**Conditional Use Permit —8001 S 120th Street —  
Nebraska Multi-Sport Complex**

**CITY OF LA VISTA  
PLANNING DIVISION  
RECOMMENDATION REPORT**

CASE NUMBERS: PCUP21-0006;

FOR HEARING ON: APRIL 7, 2022  
REPORT PREPARED ON: MARCH 30, 2022

**Figure 12. Typical Site-generated Trips**

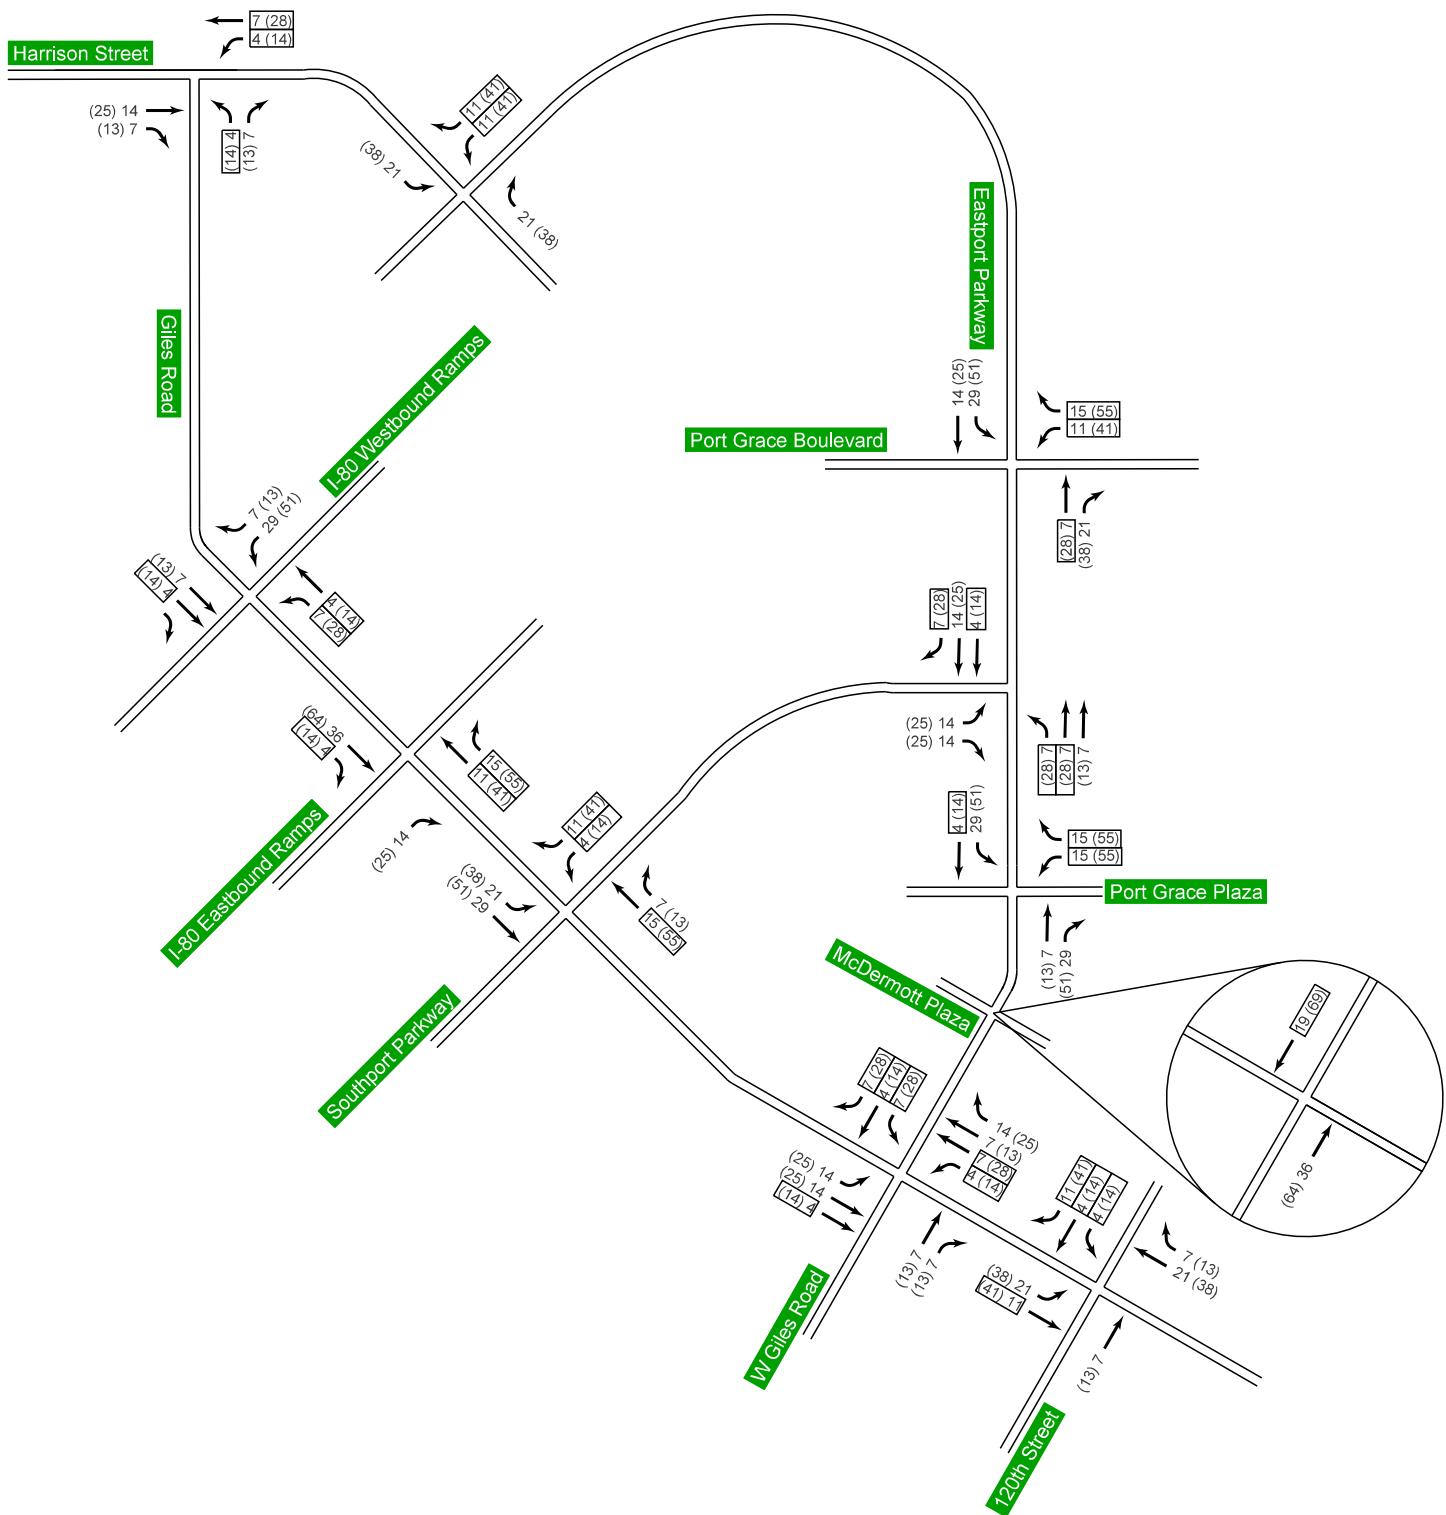
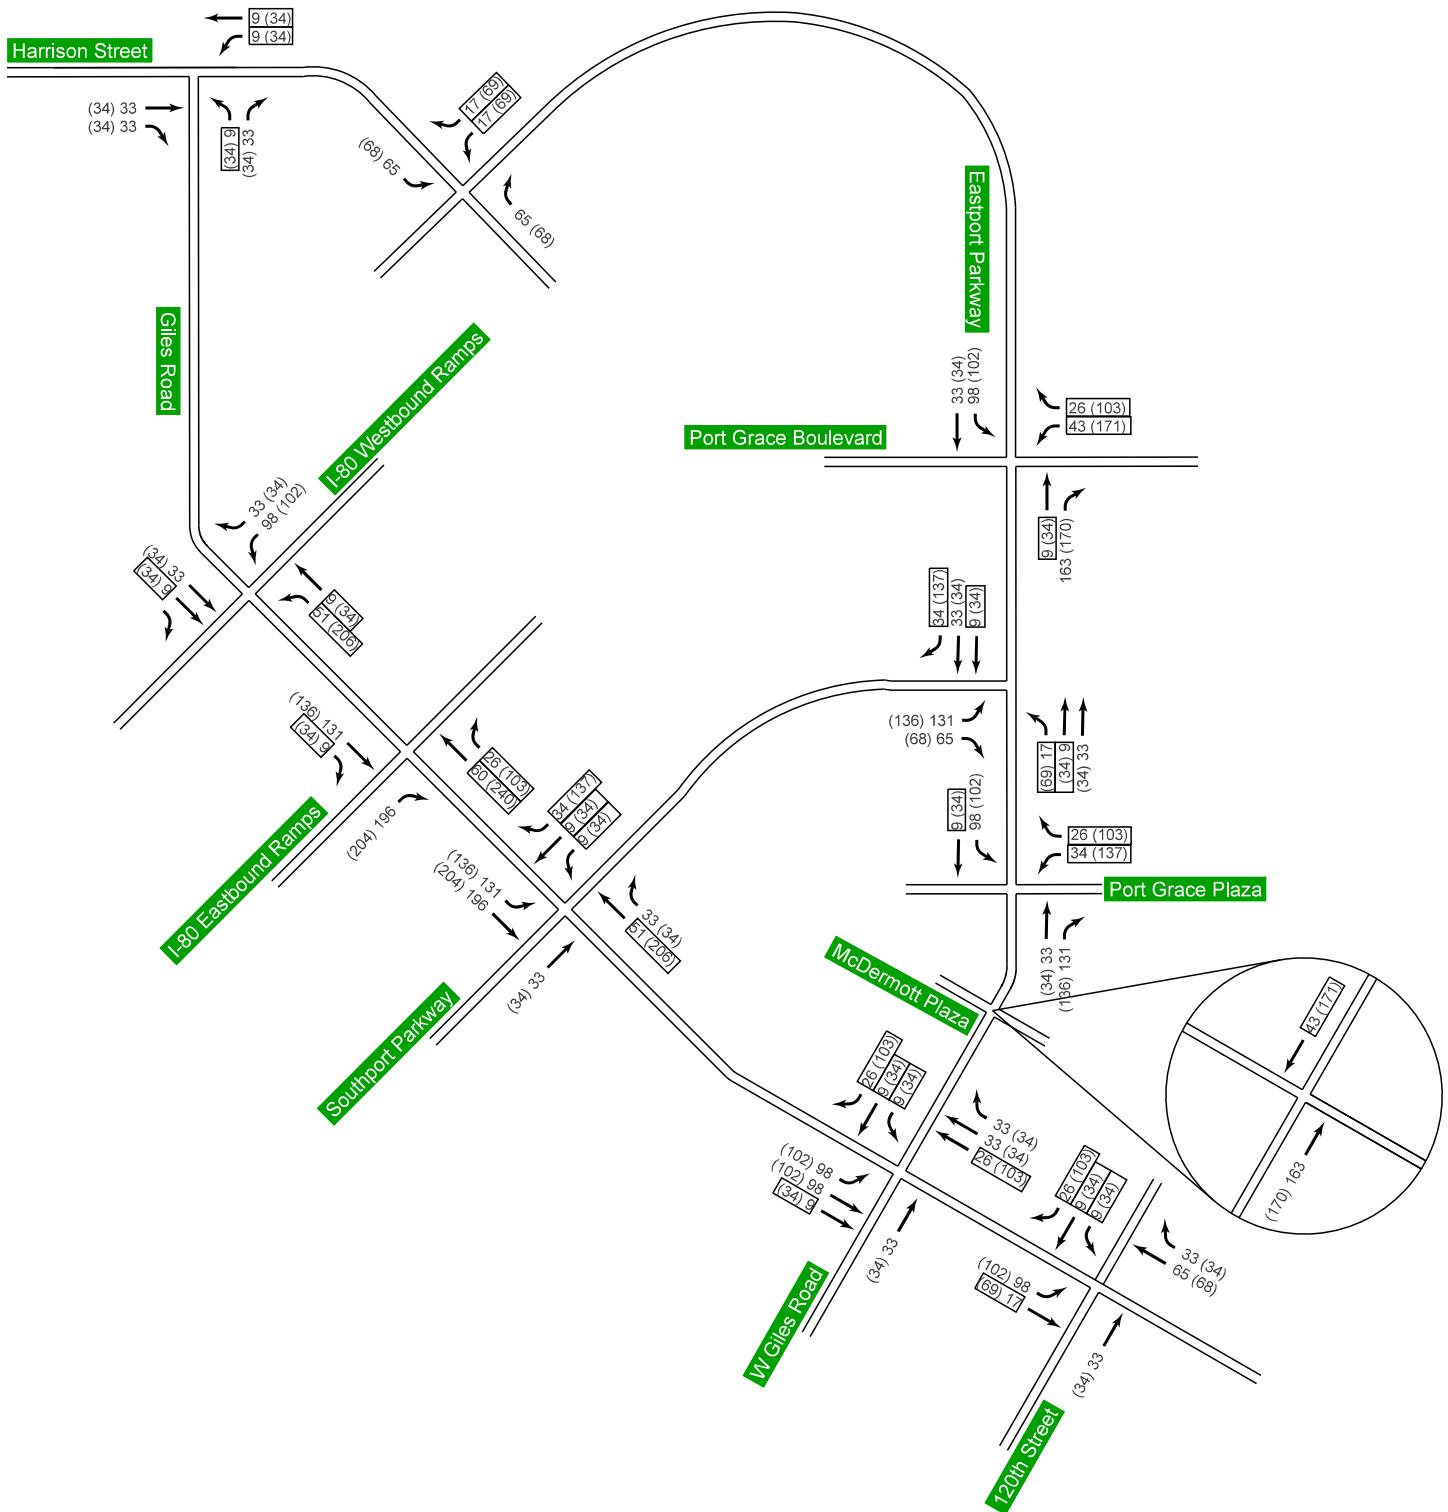
8. Page 25 & 26 / Figure 12 & Figure 13: At the intersection of 120<sup>th</sup> Street with Giles Road, trip generations are shown on the northbound left-turn movement. Trip distributions figures show these site -generated volumes should be through movements.  
*Please have the applicant update Figure 12 and Figure 13 to show the correct site-generated trips at the intersection of 120<sup>th</sup> Street and Giles Road.*

**Figure 19. 2050 plus Event Traffic Volumes**

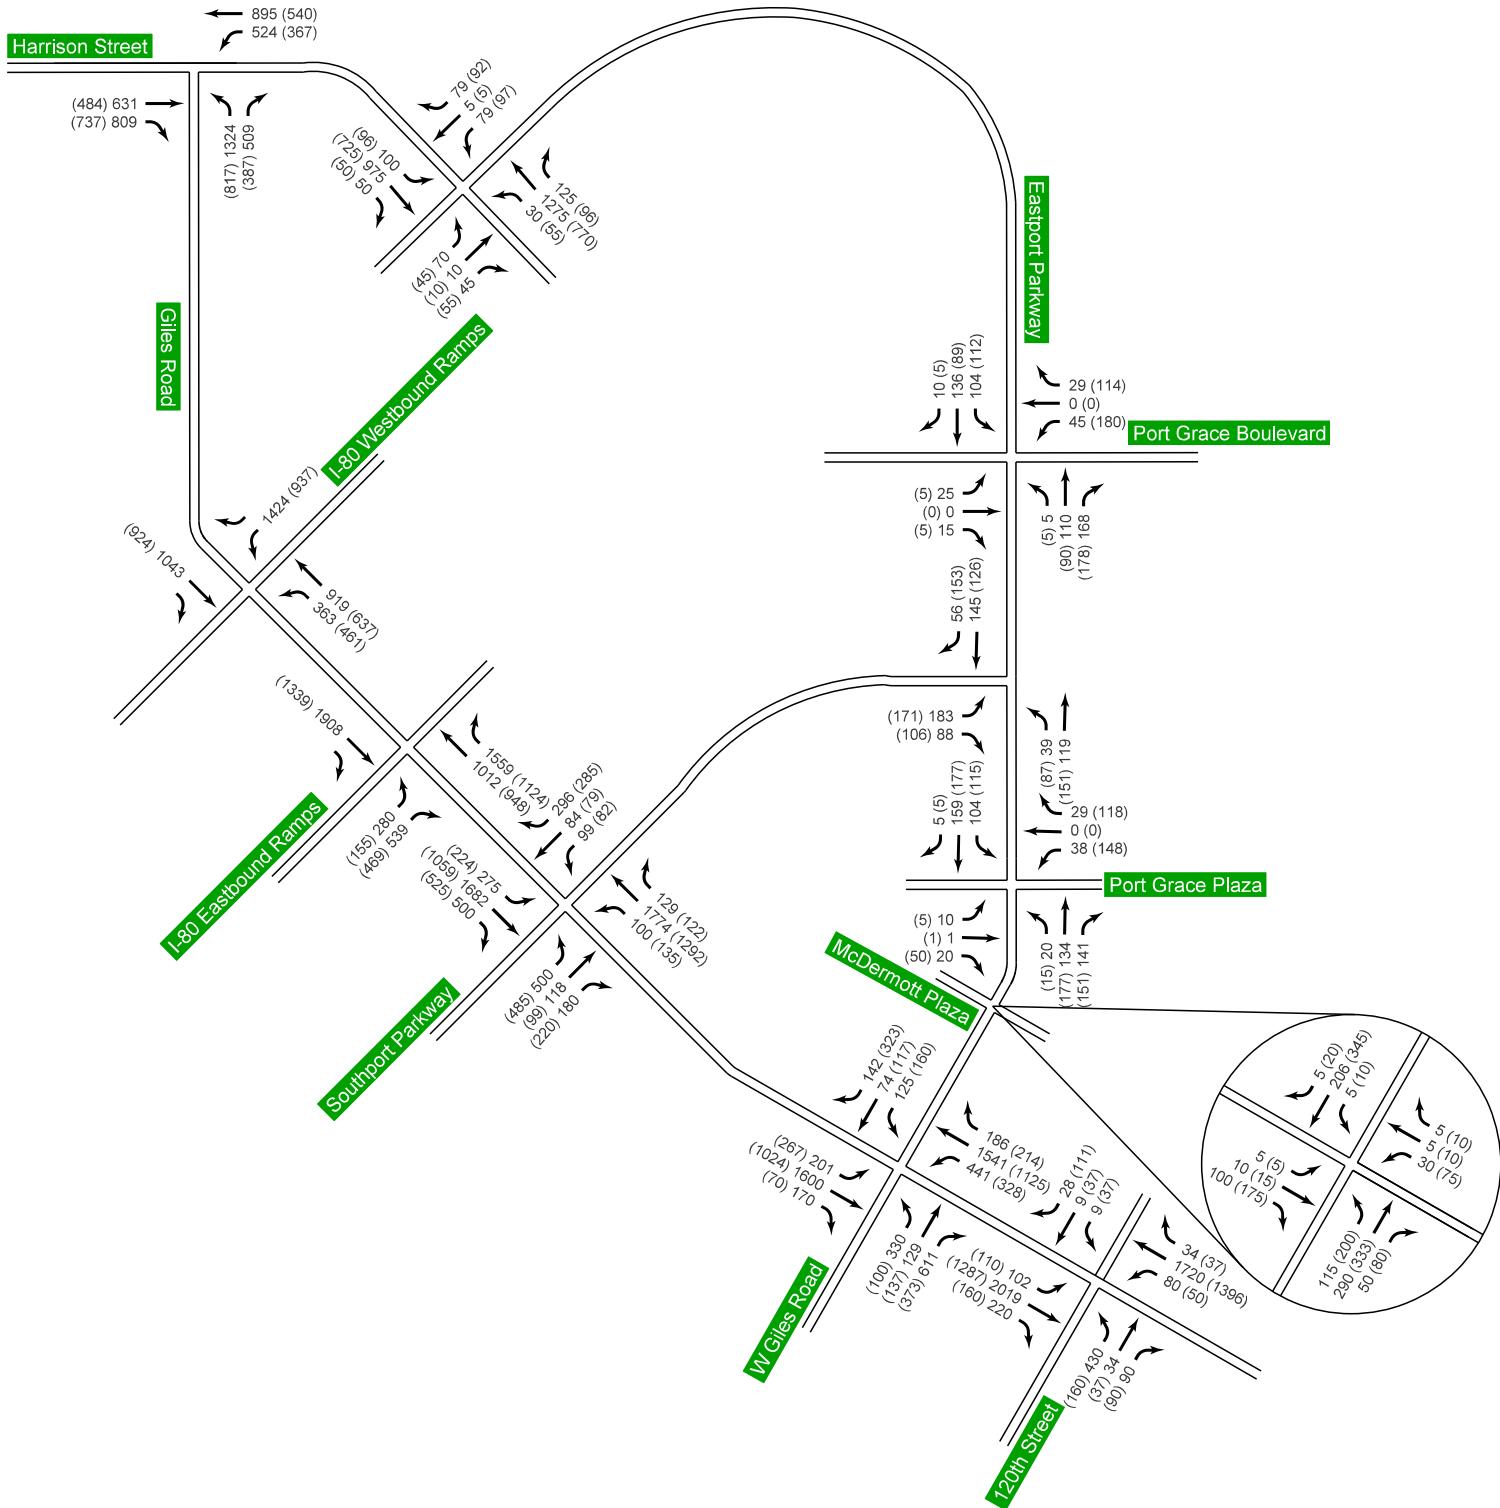
9. Page 35 / Figure 19: Figure 19 is labeled incorrectly.  
*Please have the applicant update the figure name from 2025 to 2050.*
10. Page 44 / 120<sup>th</sup> Street and Giles Road: List of improvements should include installing a new traffic signal for the proposed north leg (SW corner). Modifications may be required to the NE signal pole to accommodate the site drive and the northbound dual-left turn lanes.  
*Please have the applicant add install traffic signal/traffic signal modifications to*

Figure 21. 2050 plus Event Capacity Analysis Summary

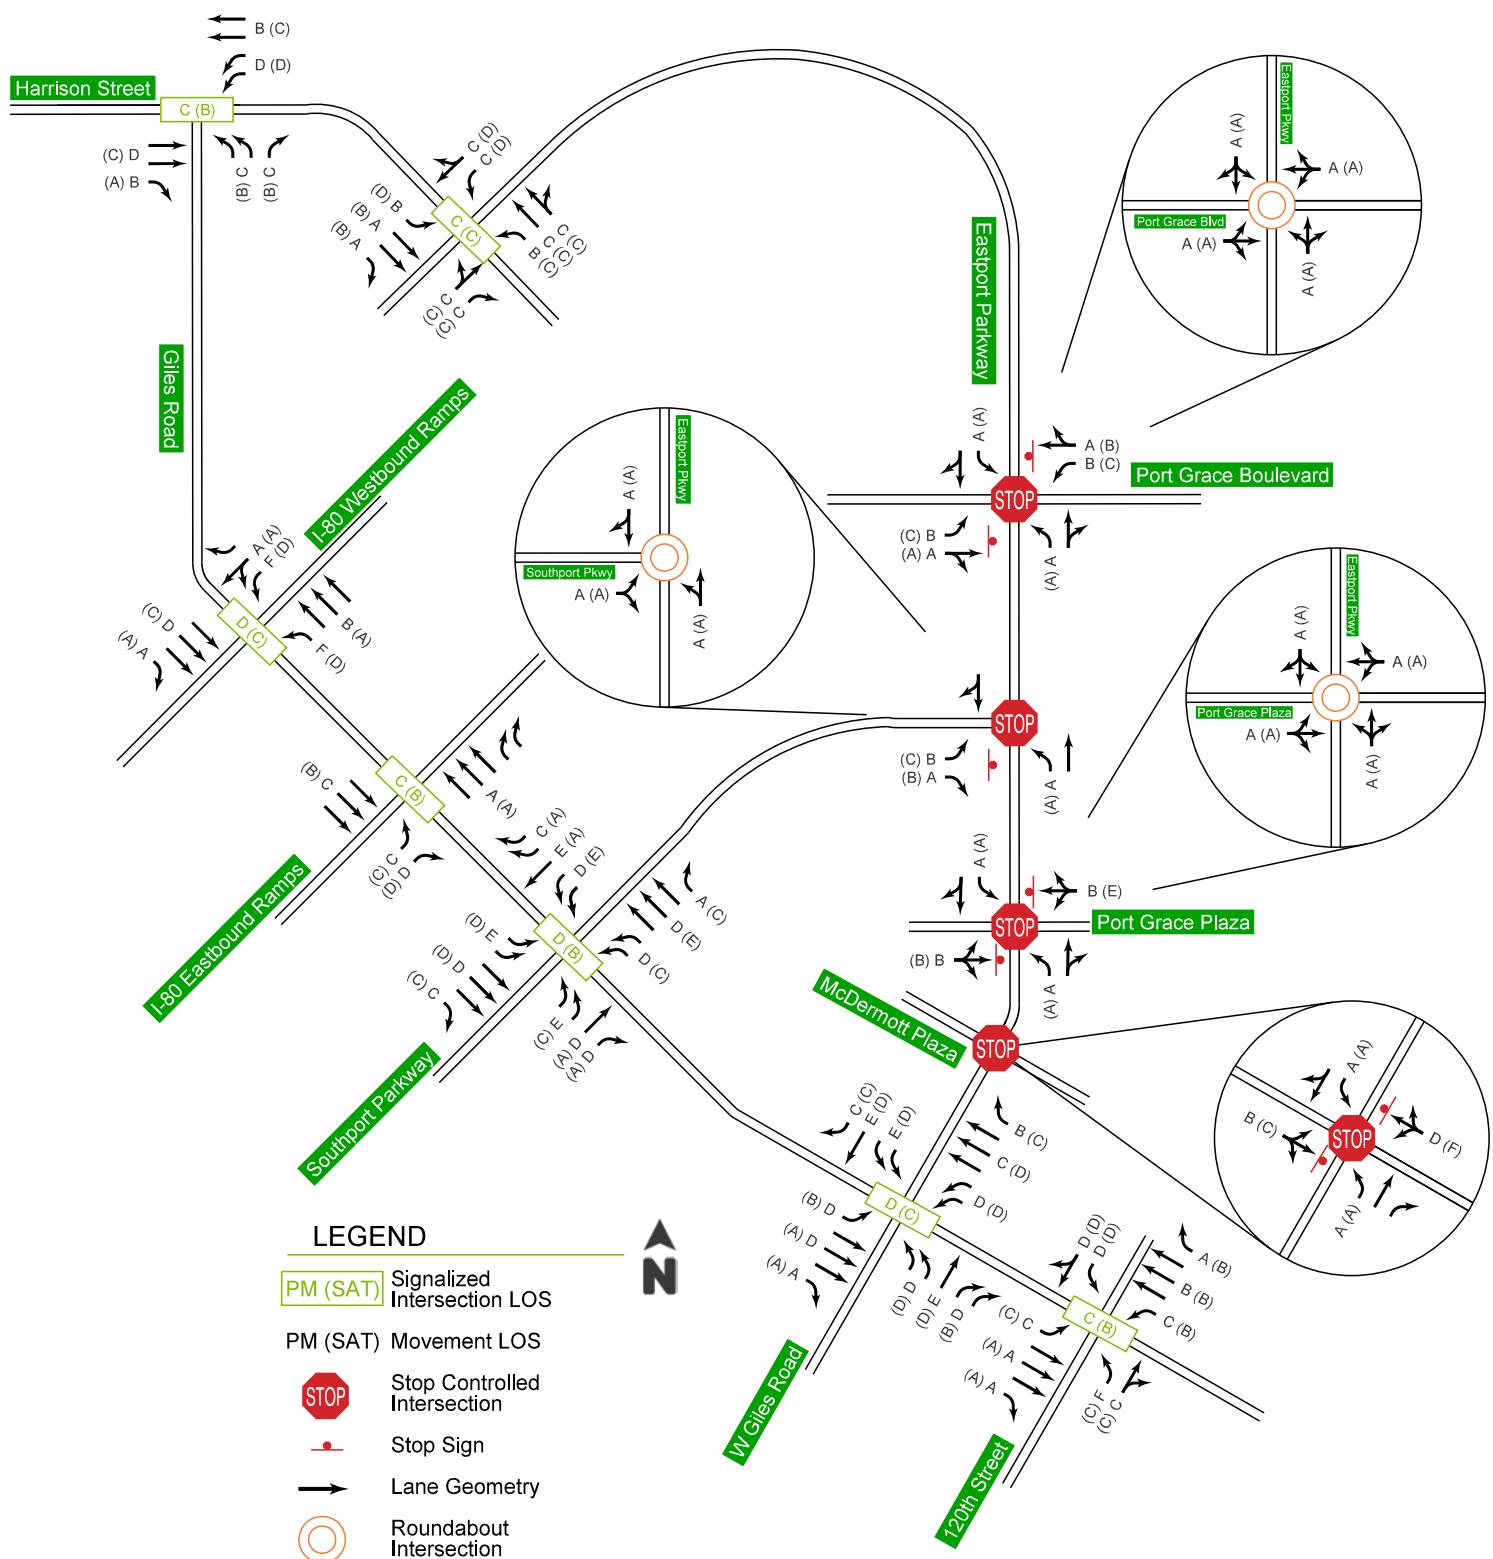
11. General: I-80 and Giles Road Interchange: Exclusive dual northbound right-turn lanes were recommended at the intersection of Giles Road with I-80 Eastbound Ramps, as shown on Page 39 / Figure 21. The recommendations shown on Page 44 / Figure 24 show the dual right-turn lanes as one shared through/right-turn lane with one exclusive right-turn lane. It should be noted that while this is a study recommendation, NDOT has not planned or supported the construction of dual northbound right-turn lanes at this location. Further coordination with NDOT will be required.  
*Please have the applicant clarify which lane configuration is recommended and update analysis and figures accordingly.*
